Southgate City Council Agenda

Re: Planned Development Phase 1 Site Plan Approval for 15601 Northline (Aquinas)

Site Plan Review

**Re: Self Storage 15601 North Line Road
Post Planning Commission Review #1, City of Southgate
Hennessey Engineers Plan Review #12240**

XTOR CROSSTOUR LED

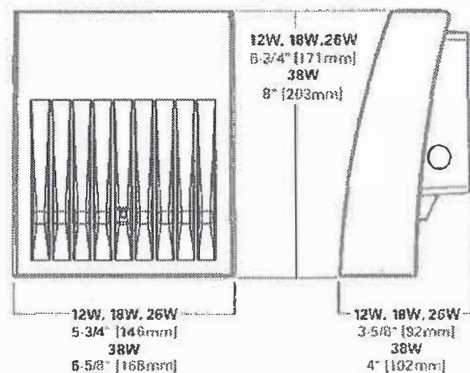
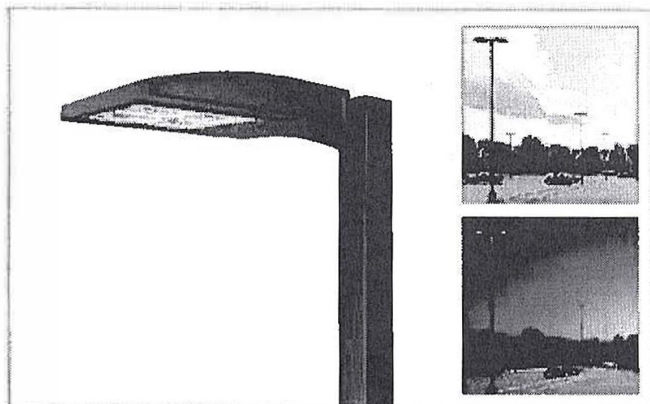
A photometric plan and fixture details have been provided, and we are of the opinion the proposed lighting is adequate and will not have an adverse effect on surrounding properties. It should also be noted that all exterior lights appear to be down shielded. The height of proposed lighting fixtures is unclear, and we ask the applicant to provide greater clarification. In addition, current lighting levels show zero (0) footcandle measurements at property lines.

Items to be Addressed: Clarify height of proposed light fixture.

OVERALL DEVELOPMENT PLAN

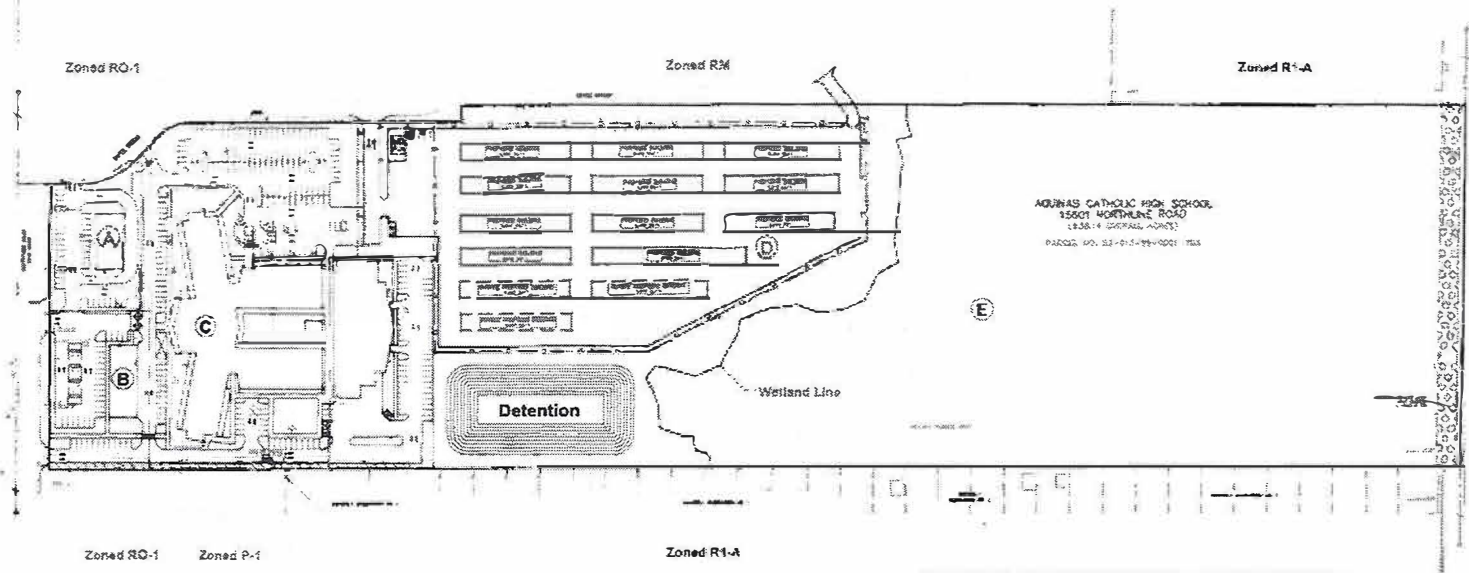
Building Location(s): The proposed self-storage facility will consist of fourteen (14) buildings varying in size arranged throughout the site. The proposed buildings are arranged in three (3) rows in a symmetrical pattern. The buildings are shown to be accessed via an automatic sliding gate on the north side of the property. We ask the applicant to clarify the intended hours of operation of the facility.

Items to be Addressed: Provide hours of operation.

We ask the applicant to clarify how many employees will be present during the largest shift, and if any company vehicles will be used. At least five (5) spaces are required. Four (4) total spaces including one (1) ADA space have been provided. Two (2) additional parking spaces plus the amount used for the calculation of employees and company vehicles will need to be added.

Items to be Addressed: 1) Add parking spaces based on employee and company vehicle counts. 2) Correct parking stall length calculation in parking area to show nineteen (19) feet.

Site Access: The self-storage facility will be accessed by an eighty (80) foot wide access drive along Devoe Street. A second access drive fifty (50) feet wide is proposed on the southeastern corner of the site strictly for emergency vehicle access. We ask the applicant to provide proof that proper approval has been granted to conduct work along the street.

Circulation: Maneuvering lane widths are based on the angle of parking spaces, in this case 0 (parallel parking spaces along storage units) and 90-degree (office parking) spaces are proposed, where maneuvering lanes are required to be twelve (12) and twenty-two (22) ft. in width, respectively. All vehicle lanes proposed on site are at least 24 feet wide, meeting ordinance requirements. We ask the applicant to provide turning radii illustrations to ensure the site can provide adequate circulation for emergency and garbage vehicles. We also suggest the northern portion of the proposed vinyl fence be moved south to provide additional maneuverability for the southernmost parking space.

Items to be Addressed: 1) Confirm approval to conduct work along Devoe Street. 2) Provide turning radii for emergency and garbage vehicles. 3) Clarify use of dumpster enclosure.

PRELIMINARY LANDSCAPE PLAN

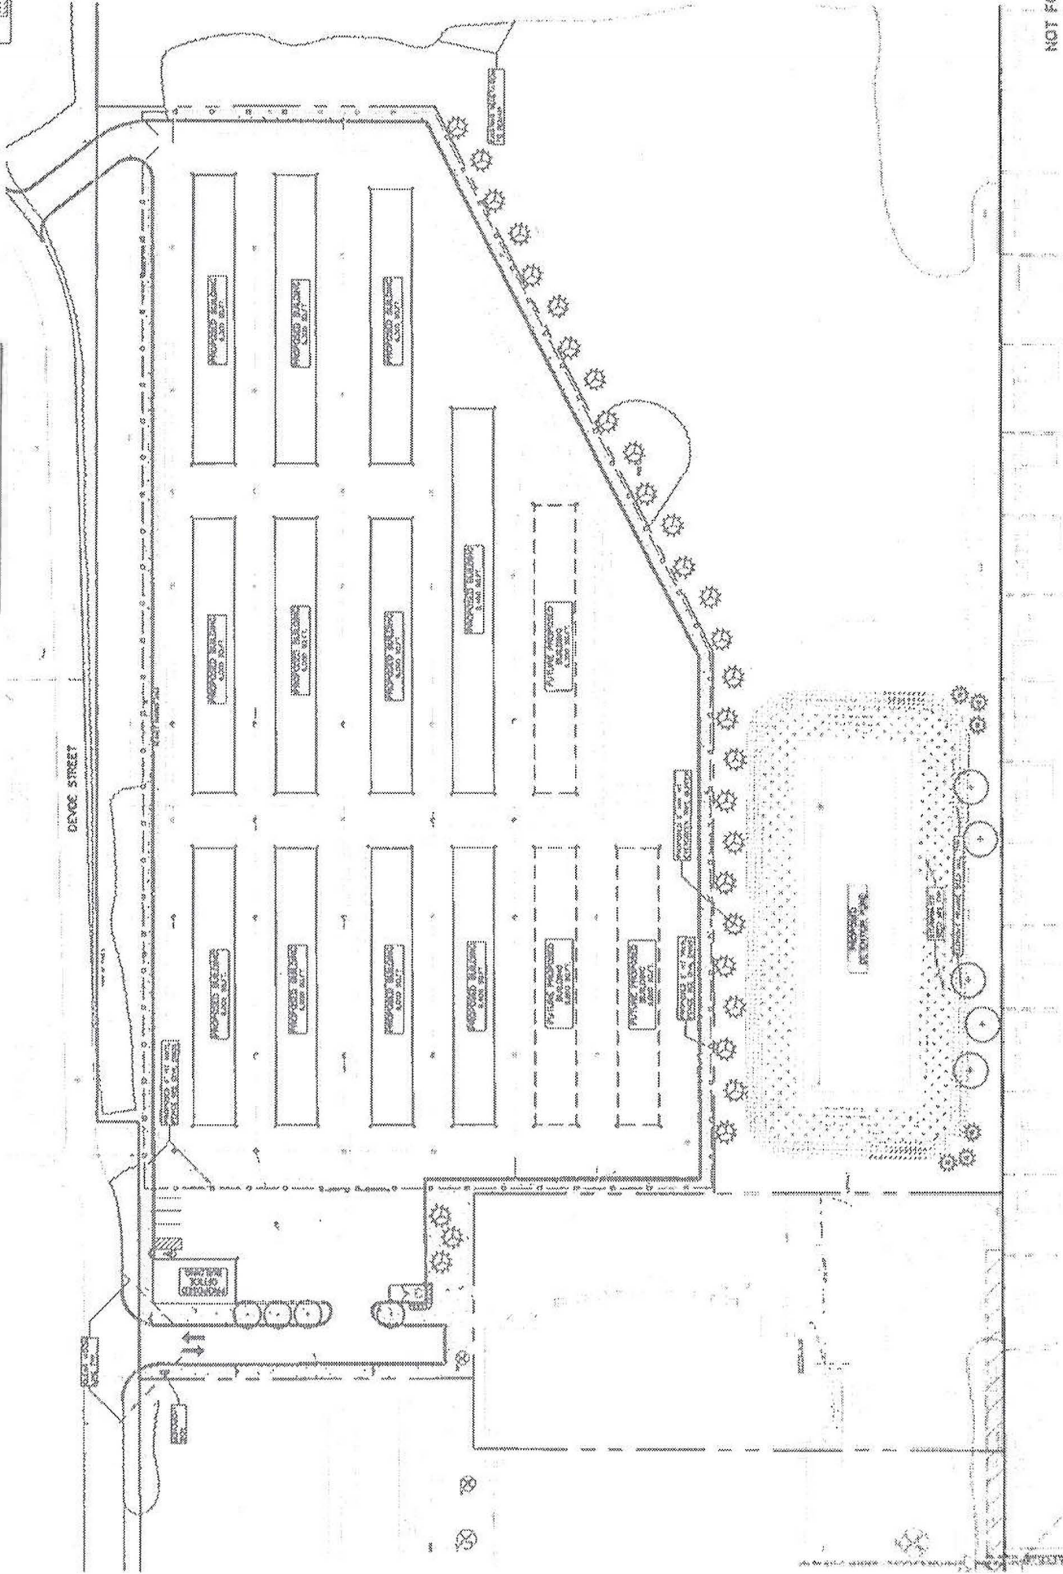
A landscape plan has been provided on sheet L-1.0.

- Street Trees:** No street trees are proposed along Devoe Street. Previous conversations with the applicant included the installation of a “living” screening wall, consisting of green planting along the face. We are of the opinion that a living wall is the minimum necessary to provide an adequate buffer between the site and the existing apartment complex to the east.

- Greenbelt Buffer:** No greenbelt plantings are shown, and we are of the opinion a greenbelt in the form of a living wall as mentioned above or additional trees to the satisfaction of the Planning Commission is required on the eastern side of the site.

- Fencing:** A six (6) foot tall vinyl fence is proposed around the perimeter of the storage area. The portion of the fence along Devoe street will need to be altered to meet the living wall requirement as mentioned above. Screening trees are provided along the remaining perimeter. We ask the applicant to clarify the height of the proposed fence as details on sheet C-9.0 show the vinyl siding to be five (5) feet in height. We also ask the applicant to change the material of the vinyl fence around the site to industrial panel walls that have the appearance of stone to provide a greater sense of screening.

Per section 1298.09, a landscape plan shall also consist of planting cross-section details, which has been provided on sheet L-1.1. A planting schedule including plant species and caliper planting size has not been provided and is required to ensure all proposed species are non-invasive. A wide variety of species is recommended to provide greater site resiliency.

Items to be Addressed: 1) Convert fencing along Devoe Street to include living plant material. 2) Provide planting schedule. 3) Clarify height of proposed vinyl fence. 4) Change fencing material of site fence to have stone appearance.
